ADDENDUM NO. 1

TO: PLANS AND SPECIFICATIONS FOR STATE OF MISSOURI

**Renovate Lobby and Restrooms 1st and 2nd Floor
Howerton State office Building
Jefferson City, Missouri
PROJECT NO.: O2339-01**

A-204

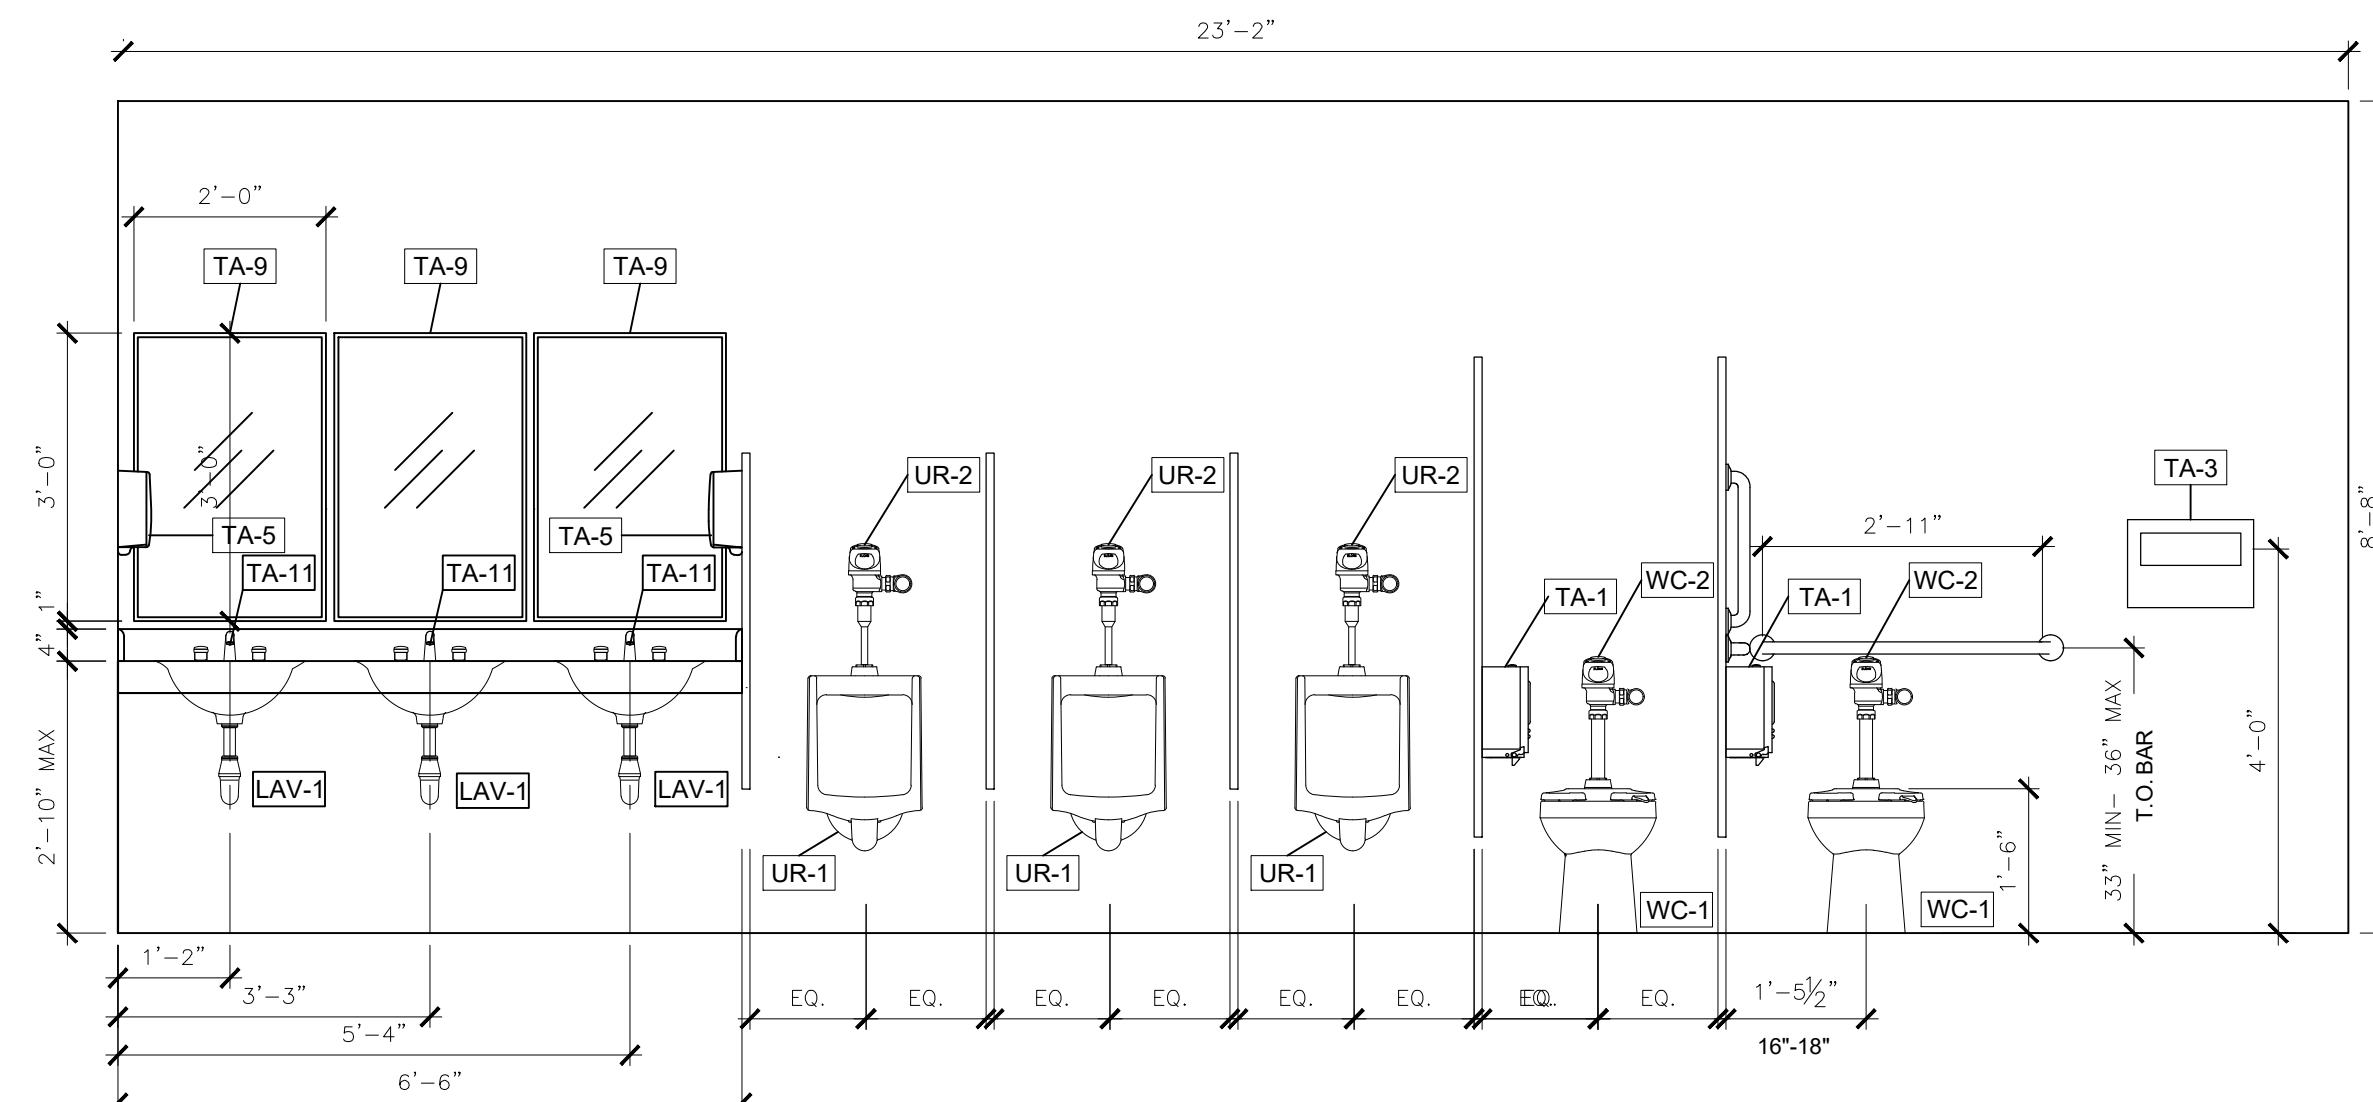
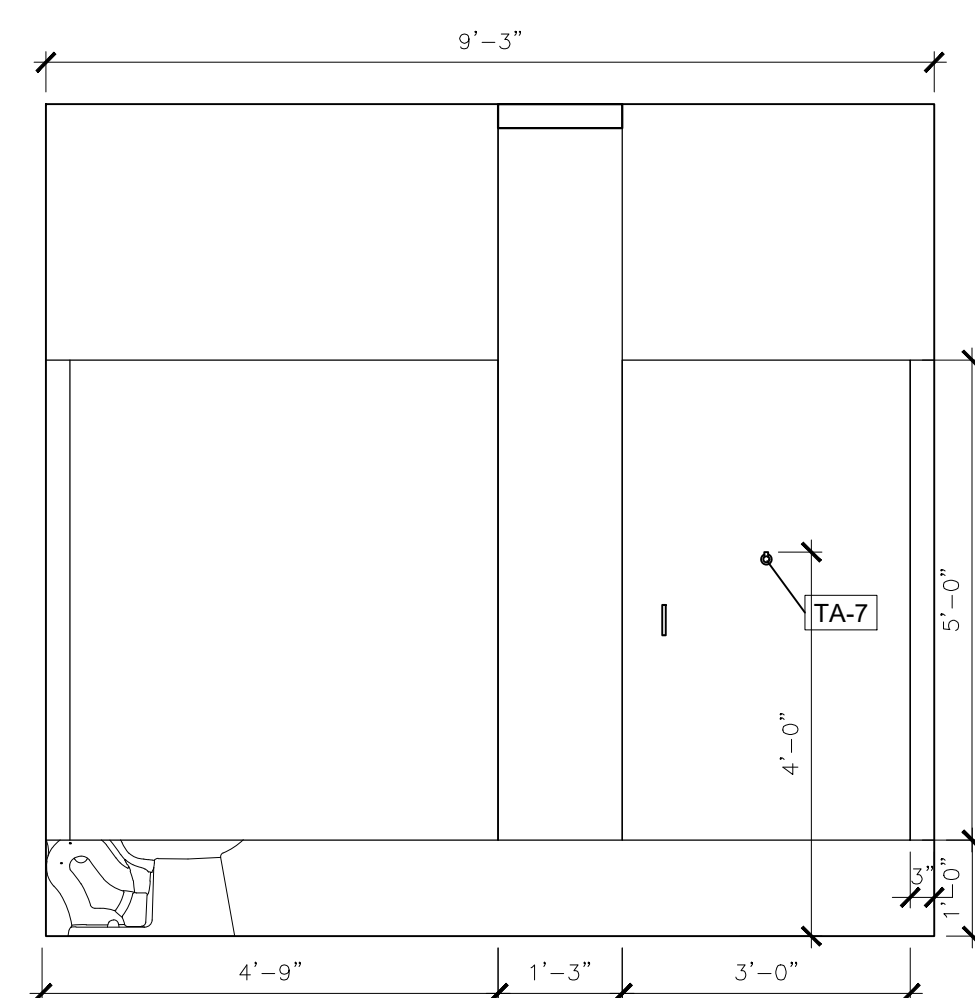
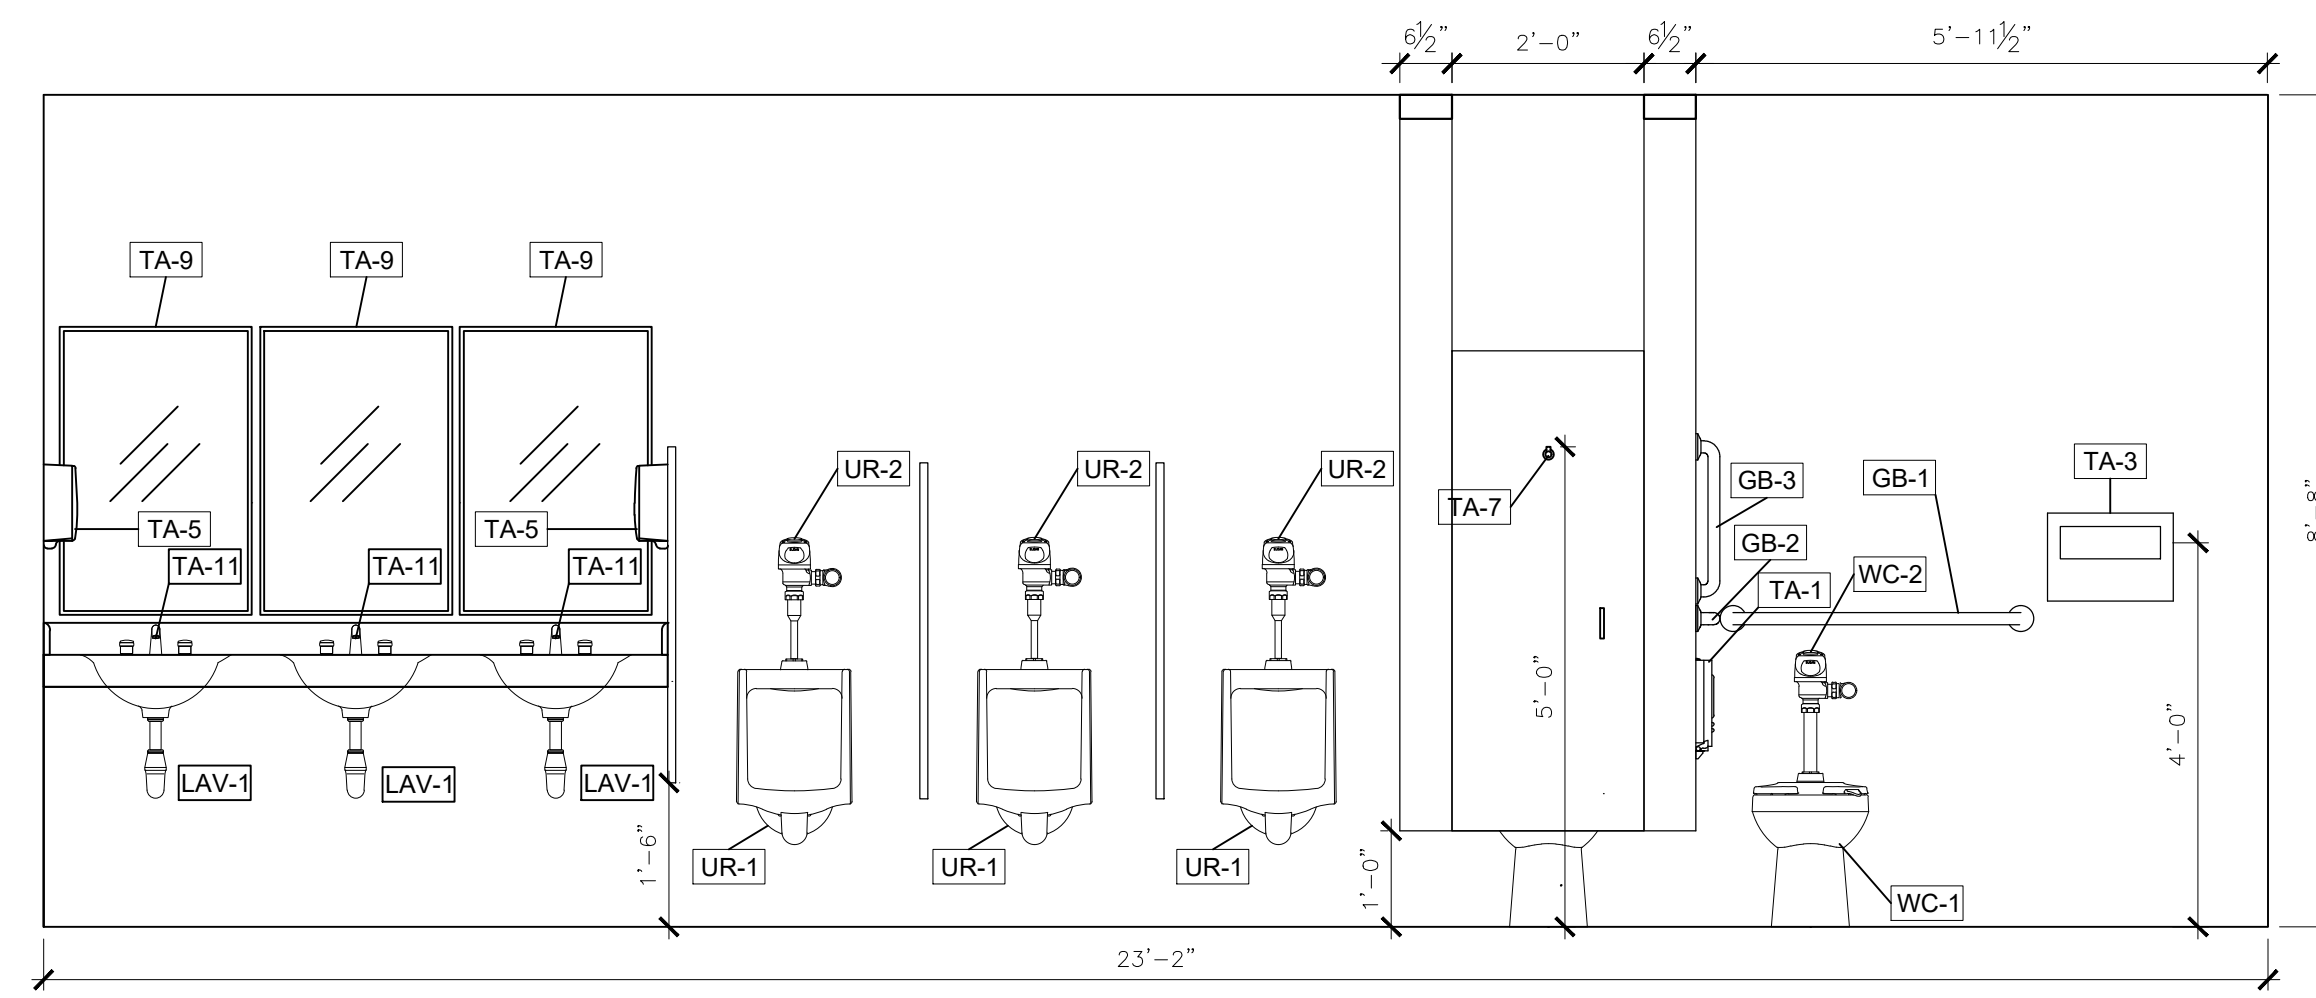
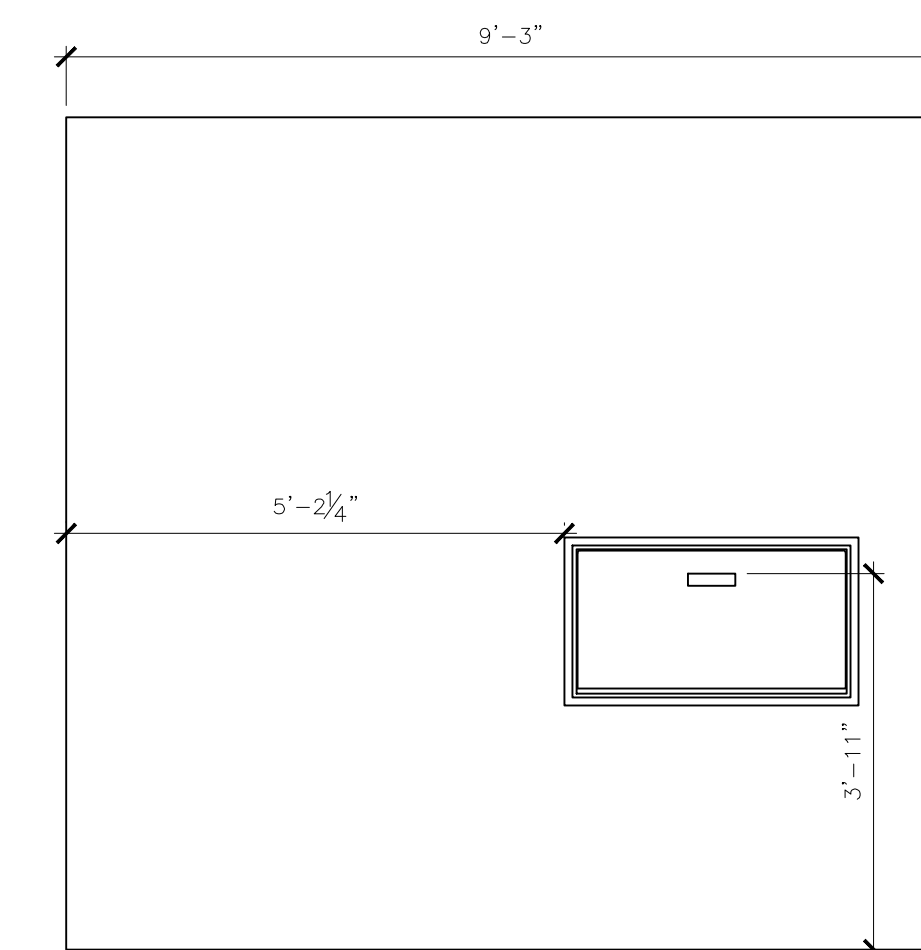
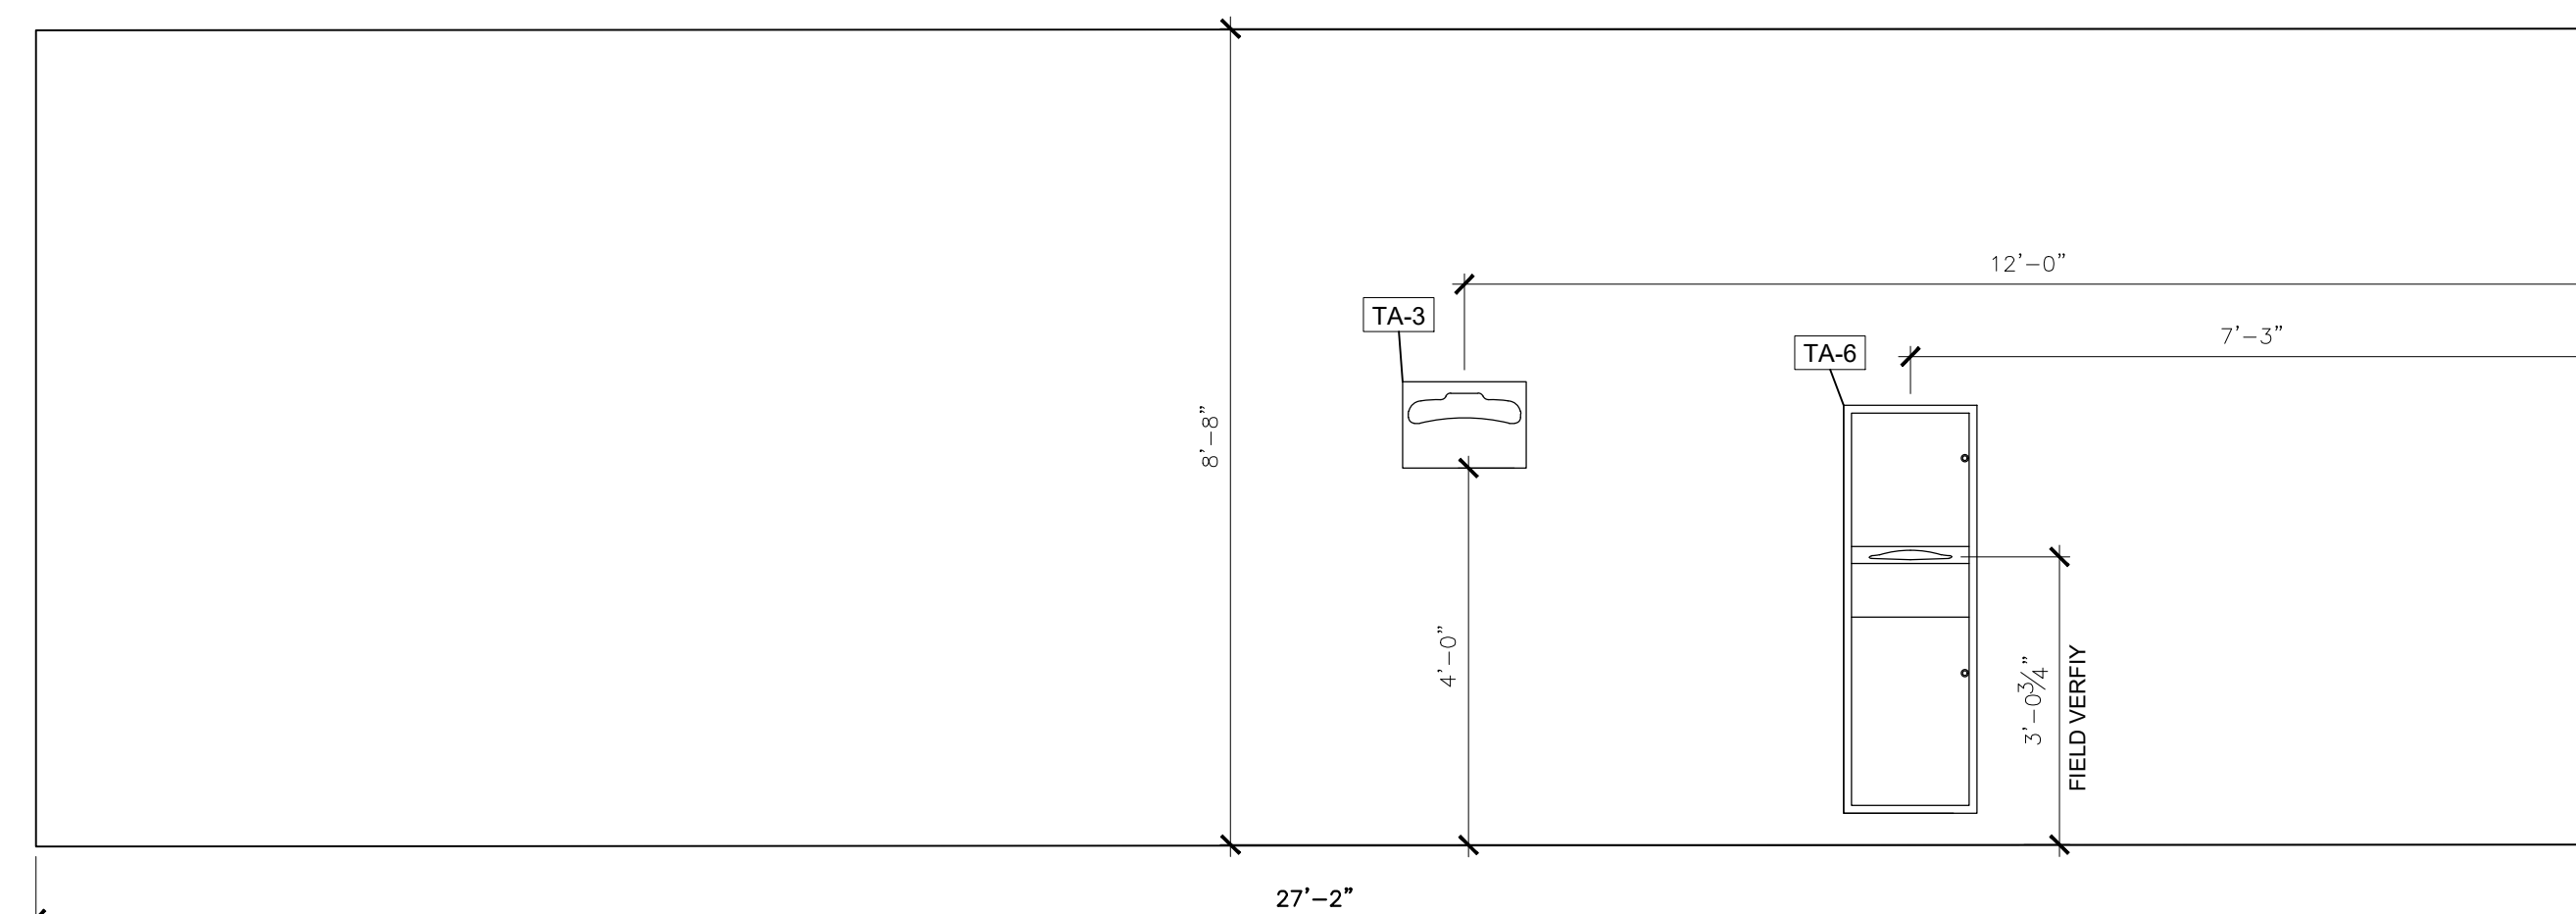
A-204

- 1. Restroom Finish Schedule: Clarifications per mark.
 - GB-1 Changed grab bar to 36" grab bar.
 - GB-2 Changed grab bar to 42" grab bar.
 - GB-3 Changed grab bar to 18" grab bar.
 - TA-7 Changed coat hook to coat hooks (to be installed inside of stalls)
 - TA-8 Changed mirror to 24" x 72" mirror.
 - TA-9 Changed mirror to 24" x 36" mirror.
- 2. Changed note from: See A-601 for full fixture schedule to See sheets A-104 - A-105 for full fixture schedules.
